Access Compliance Report

Public Rights-of-Way

Intersection ID: 10675	Main Street: HERRIN_AV	Cross Street: THE_PLAZA	Location: SE
ADA ID: DFA36B37A35A	Ramp Type: Perp	Initial Pass/Fail: Fail	Overall Compliance: No
			Severity Score: 36.25

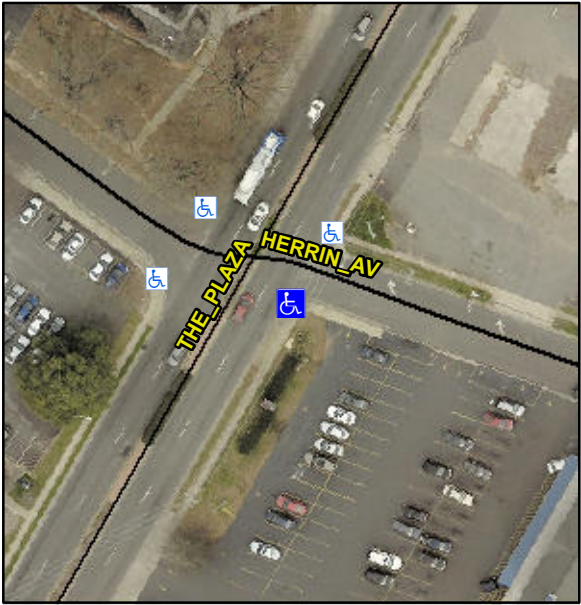
Codes/Mitigation Info/Possible Solution			Field Measurements/Component Compliance		
	Possible Solutions:		Compliance	Description	Data
	Remove & Replace Entire Ramp.		Yes	Ramp Length (in)	59.0
			No	Ramp Width (in)	30.0
			N/A	Flare Type LT	N/A
			N/A	Flare Slope LT (%)	N/A
			N/A	Flare Traversable LT?	N/A
			N/A	Landing Length (in)	N/A
			N/A	Landing Width (in)	N/A
			N/A	Landing Slope (%)	N/A
			N/A	Landing X Slope (%)	N/A
<p>Surveyor Notes:</p> <p>N/A</p>			N/A	Landing Curb? (Y/N)	N/A
			N/A	Shared Landing?	N/A
			N/A	Gutter Ponding?	N/A
			N/A	Gutter Lip Ht (in)	N/A
			N/A	Painted X Walk1?	No
			To NE	X Walk 1 Direction	N/A
			N/A	X Walk 1 Width (in)	N/A

0.0	X Walk 1 Slope (%)	N/A
			3.0	X Walk 1 X Slope (%)	N/A
			N/A	Ramp inside XWalk1?	N/A
<p>PROW/ADA:</p> <p>Not Found, R304.5.1, R304.5.3</p>			N/A	Road Slope (%)	N/A
			N/A	Road X Slope (%)	N/A
			N/A	Any Obstructions?	N/A
				Obstruction Type	
			N/A		
			N/A		
			N/A		
			N/A		
			N/A		
			N/A		
<p>Total Cost:</p> <p>\$ 1850.00</p>			Yes	Surface Condition? (G/P)	Good
